# Access Compliance Report

## Public Rights-of-Way (Curb Ramps)

Intersection ID: 53762	Main Street: W_W_T_HARRIS_BV	Cross Street: SINGH_DR	Location: SW
ADA ID: EC2FFA2F91B2	Ramp Type: Directional1	Initial Pass/Fail: Pass	Overall Compliance: No
		Severity Score: 0

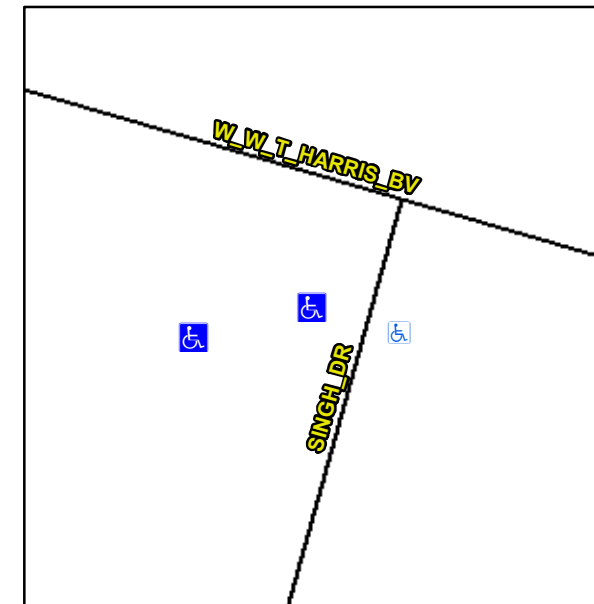
**NO RT SW**

**R304.5.3**

**Remove & Replace Gutter.**
